**Comment of Minnesota Dept. of Transportation**

Re: CapX 2020 Hampton – Rochester – La Crosse Transmission Line Project  
PUC Docket No. E002/TL-09-1448  
OAH Docket No. 7-2500-20283-2

The Minnesota Department of Transportation (Mn/DOT) has reviewed the Draft Environmental Impact Statement (DEIS) relating to the Application for a route permit filed by CapX2020 for its Hampton – La Crosse Transmission Line Project. Mn/DOT appreciates the opportunity to provide comments regarding the matters for which Mn/DOT has regulatory responsibility and other interests. Mn/DOT respectfully submits the following comments on some general matters that affect multiple portions of the DEIS as well as comments relating to some specific paragraphs of the DEIS.

# Stanton Airfield

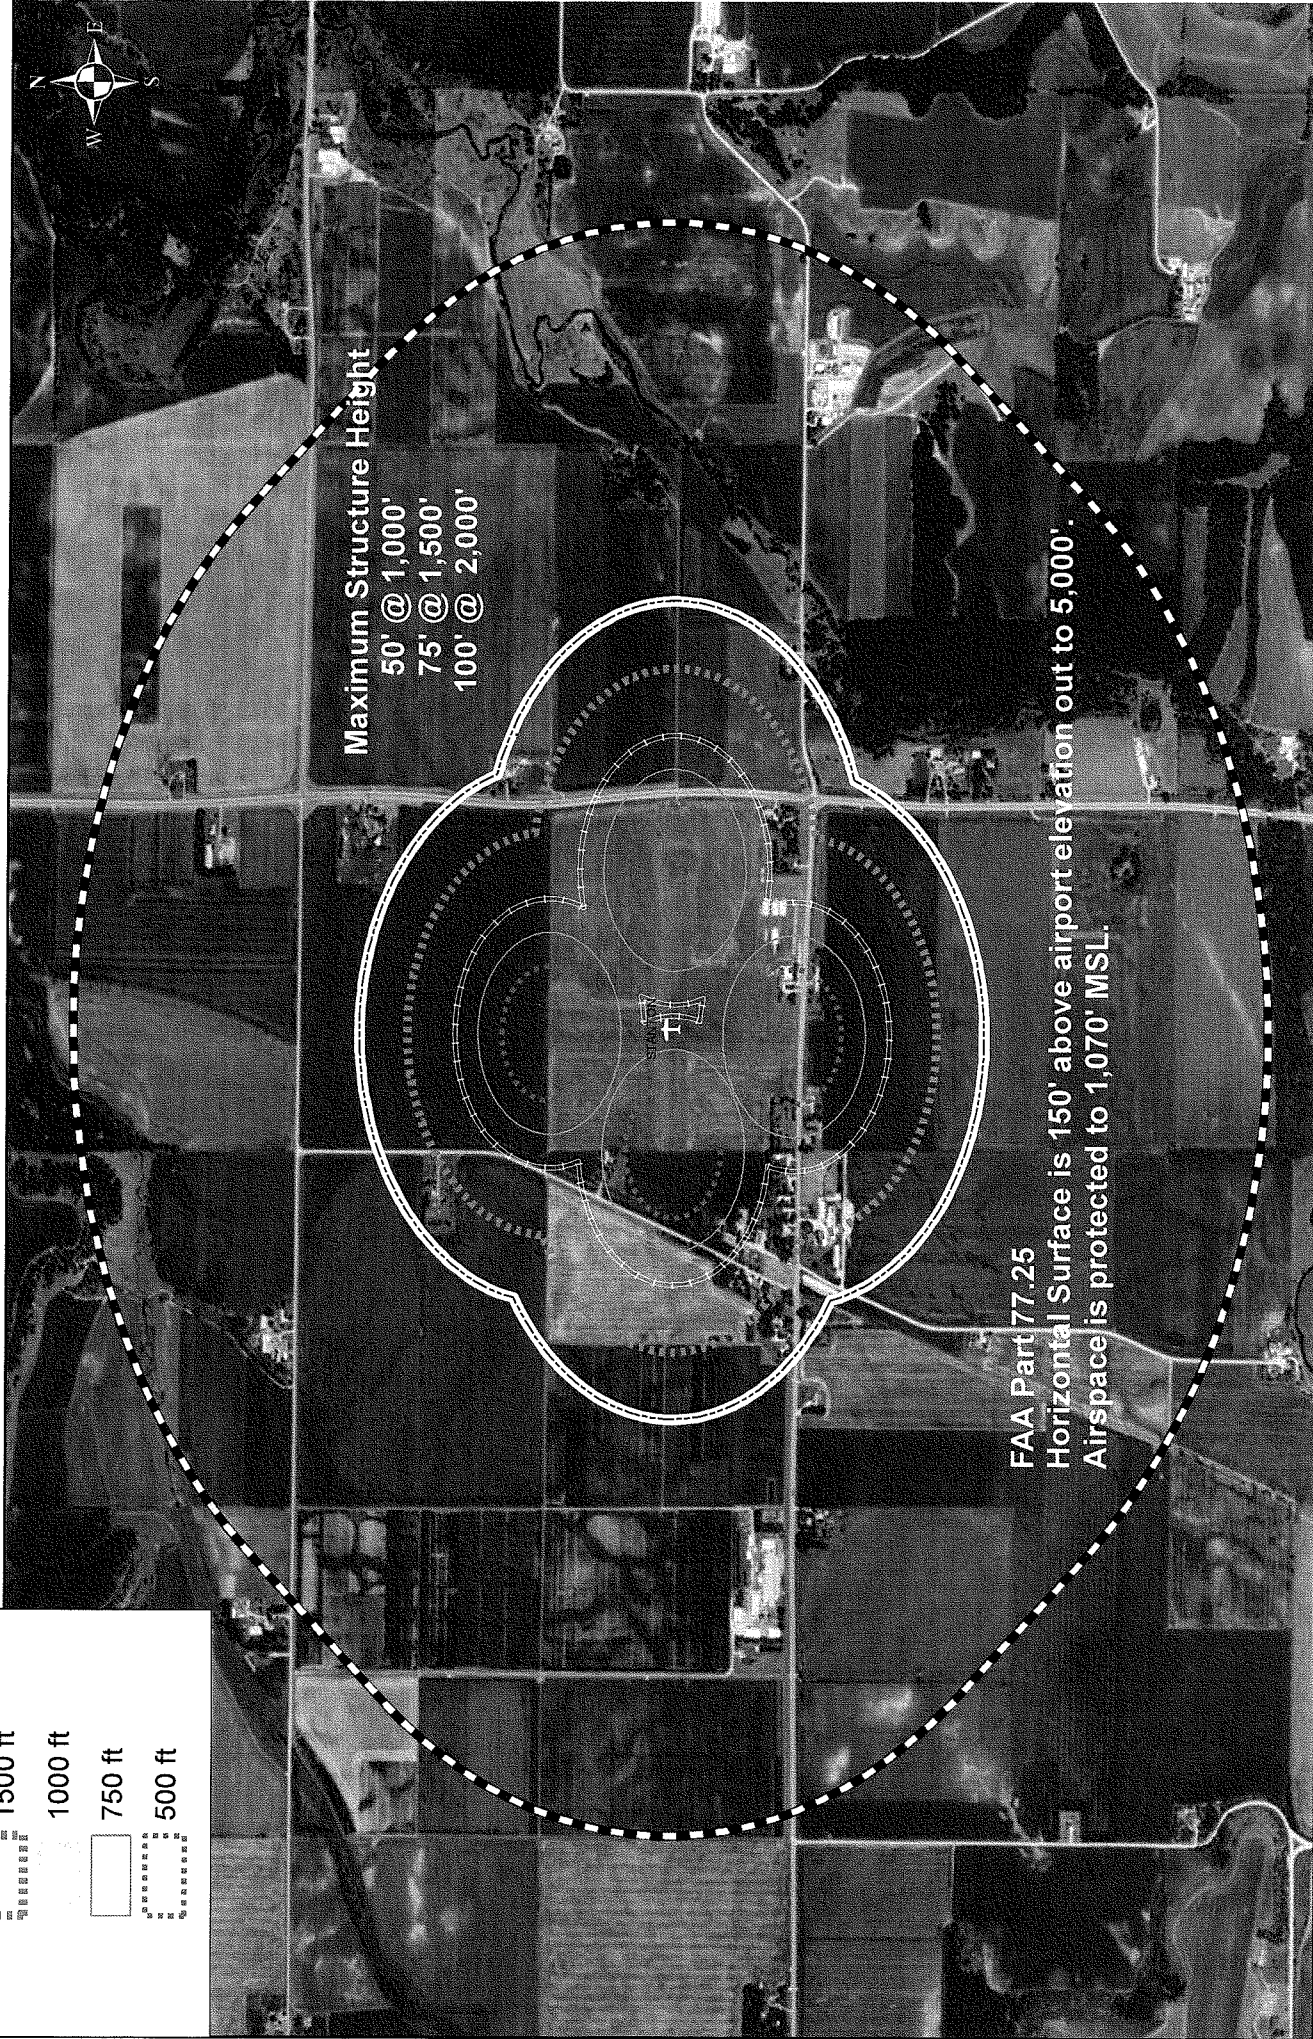
The DEIS notes in several sections where the proposed routes are close enough to airports to have a potential impact on aviation. The most significant impact to an airport open for public use is to the Stanton Airfield, which is discussed in sections 7.11.3 and 8.1.4.11. The Stanton Airfield is licensed by Mn/DOT's Office of Aeronautics, and its airspace must be protected to maintain its license. Mn/DOT's records reflect that the Stanton Airfield is not a commercial service airport.

The Stanton Airfield has two visual runways with required airspace protection for a 20:1 approach to maintain a license. The diagram enclosed as Attachment 1 depicts the airspace protection zones for the Stanton Airfield. The area inside the dashed line shows the FAA Part 77.25 horizontal surface, within which structures greater than 150 feet above the level of the runway are not permitted. The rings closer to the airfield depict locations along the 20:1 slope and representative heights of structures at those locations. For example, at the outermost of these rings, structures are limited to 100 feet in height. As the DEIS notes, proposed route alternatives 1B-005 and 1P-009 pass close enough to the east end of one of the Stanton Airfield runways as to present problems for safe operation of the airfield and continued licensing of that facility.

A filing with the Federal Aviation Administration (FAA) on FAA Form 7460-1 will be required. The DEIS should also indicate the Applicant's obligation to obtain all the required approvals from an aviation safety perspective. In addition to obtaining from the FAA a "Determination of Hazard" or "No Hazard", permits from either Mn/DOT or the local airport zoning authority are required. We are unable to determine from the DEIS whether all public airports within five miles of the project have been notified and given an opportunity to comment on compatibility of transmission lines with airport operations and land use compatibility.
